ADDENDUM NO. 01
Bean Tract Wetlands Creation Project

Owner: Calhoun Port Authority

Date: August 22, 2022

PROPOSED LAYOUT

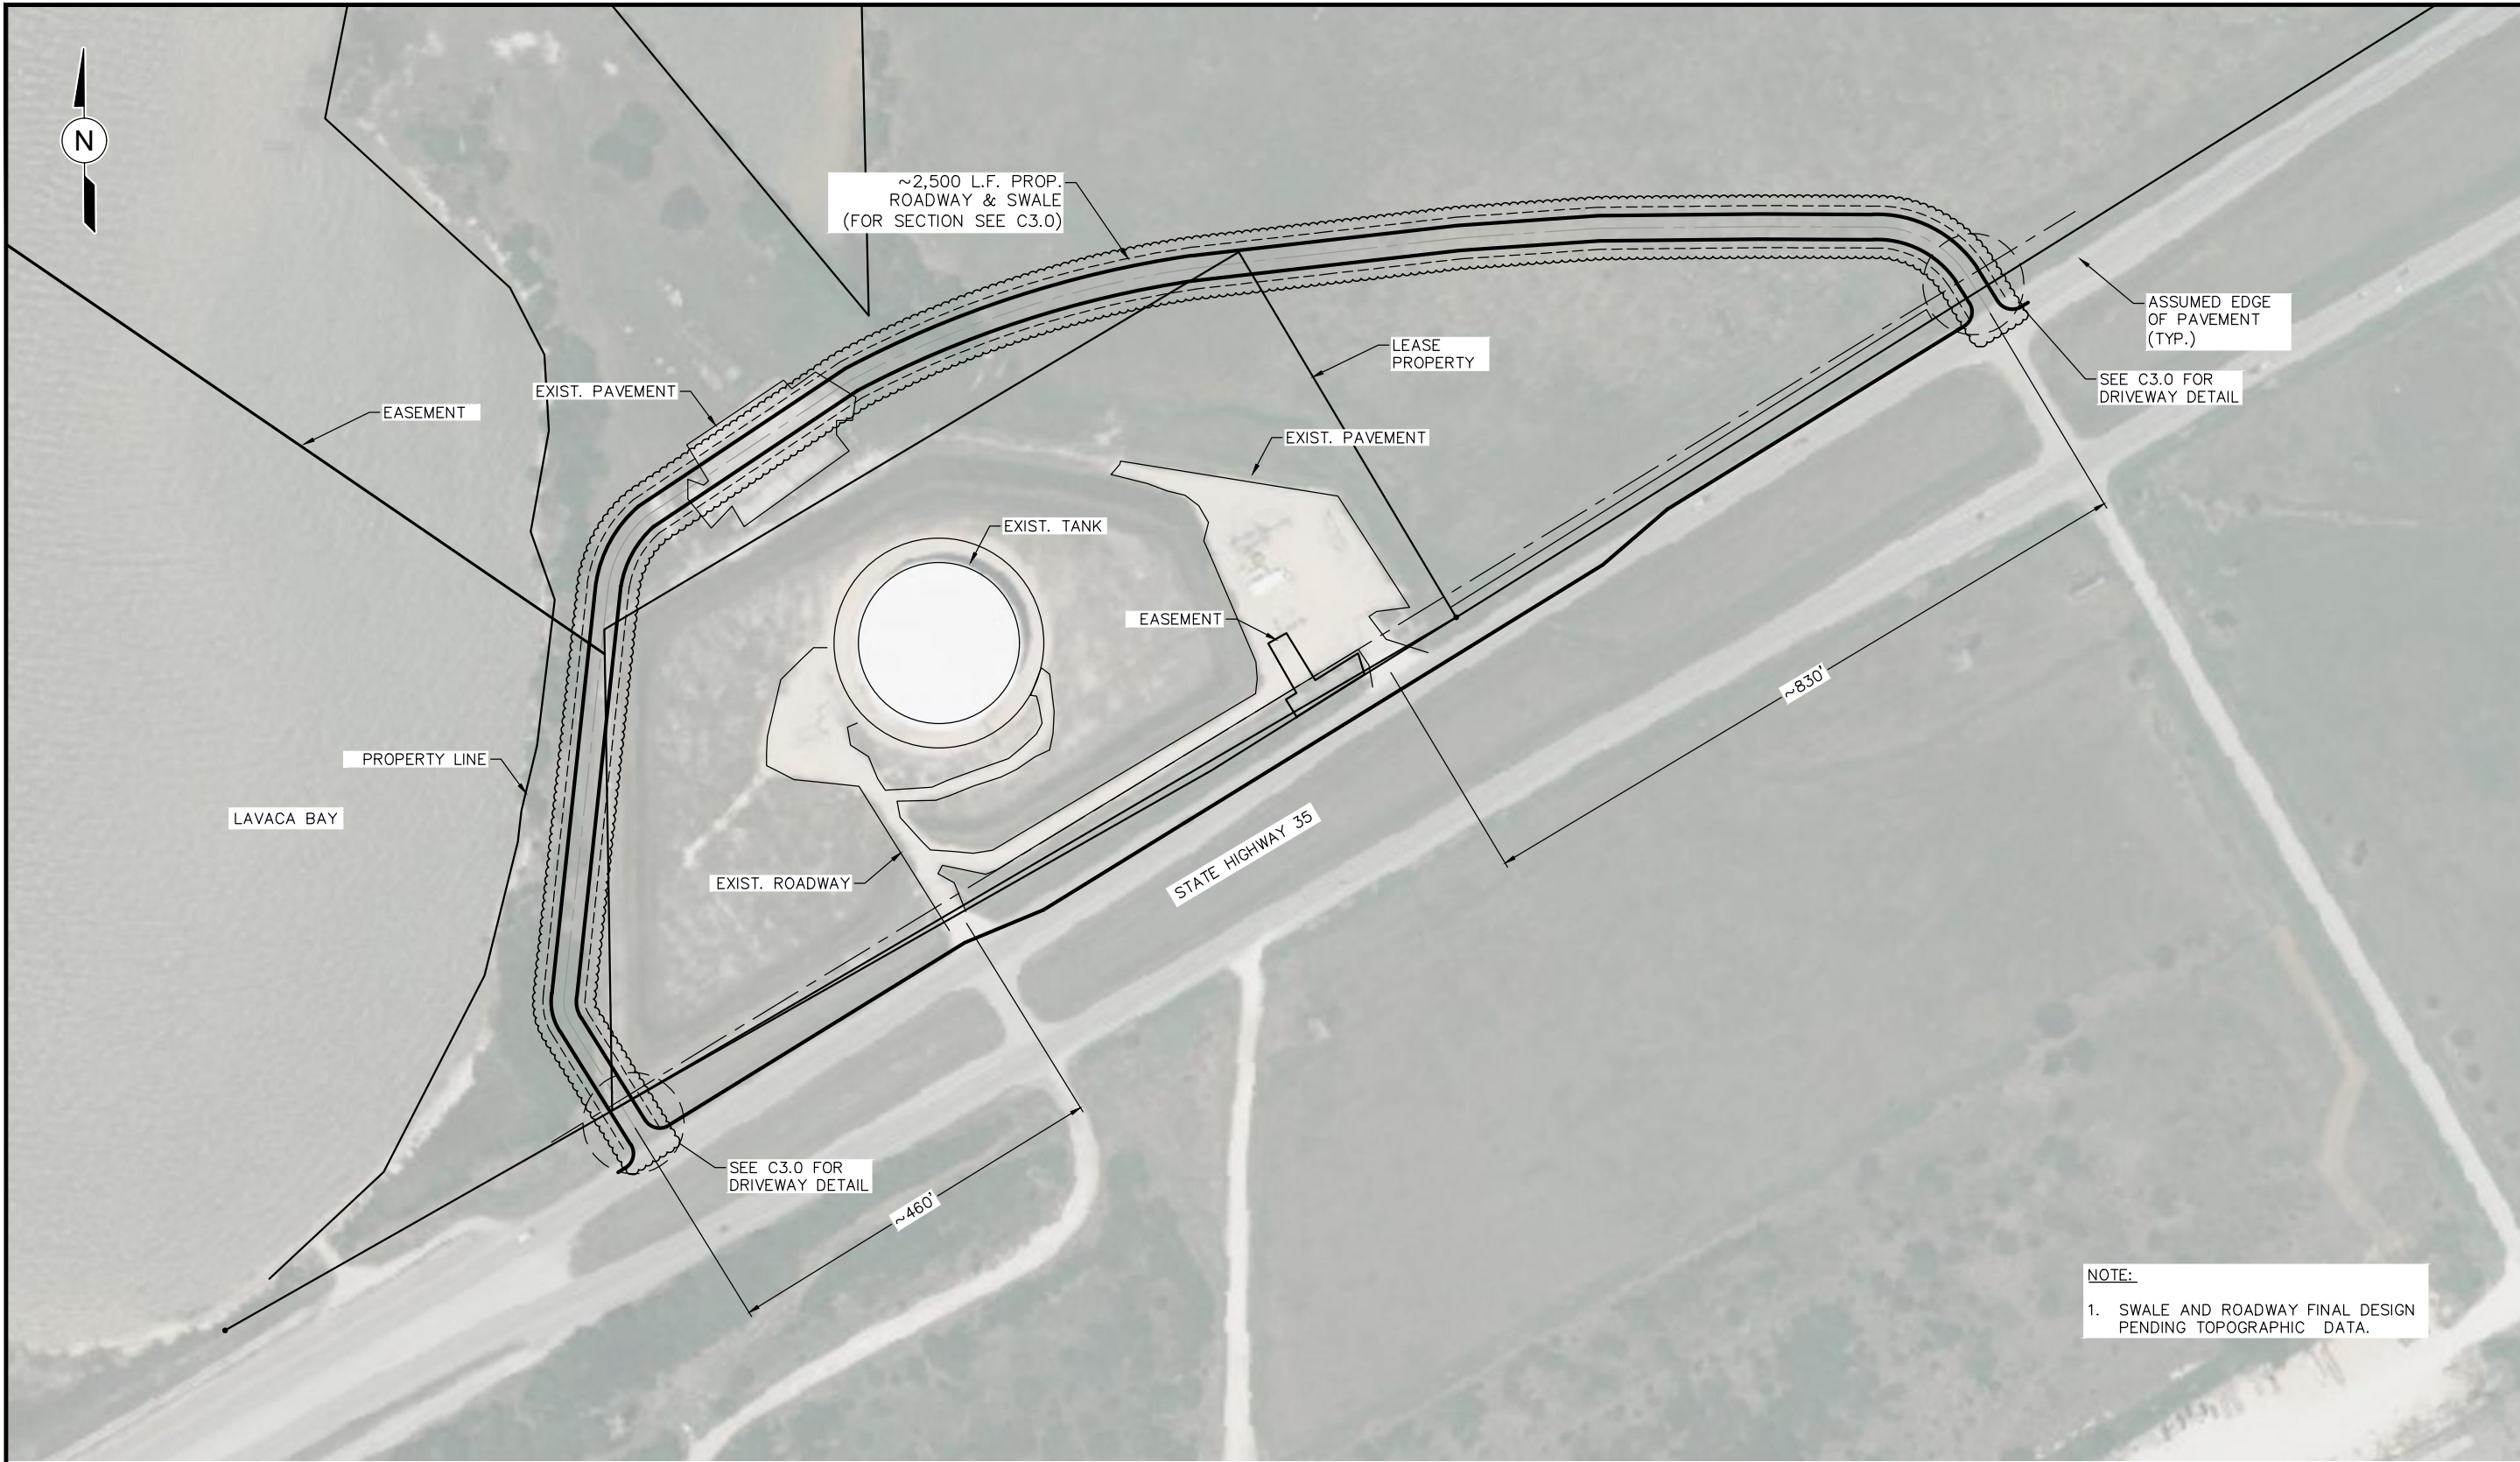
Temporary Access Road location on drawings is approximate. Temporary driveway (2 driveways expected) tie-in from the roadway to the levee are to be determined by the contractor. Required to be restored to Pre-Construction conditions.
